Office Action Summary

10/596,829

SCHMIDT ET AL.

DETAILED ACTION

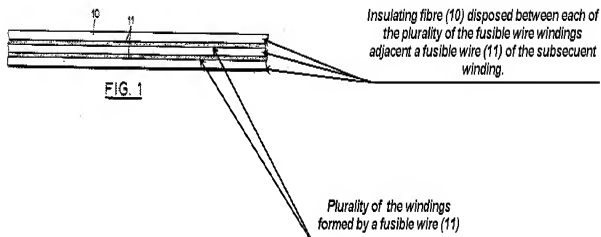
Regarding claim 12, Drothen disclosed (Fig. 2-3) a fusible conductor for a fuse element, said fusible conductor comprising: an electrically insulating core (6); a fusible wire (7) wound about the core (6) forming as a plurality of windings; and an electrically insulating fiber (10, 11) wound about the core and disposed between each of said plurality of fusible wire windings such that the insulating fiber is adjacent a fusible wire of a subsequent winding (see annotated figure below):

Plurality of windings formed by a fusible wire (7) with an insulating fiber(10) disposed therebetween adjacent the fusible wire of each of a subsequent winding
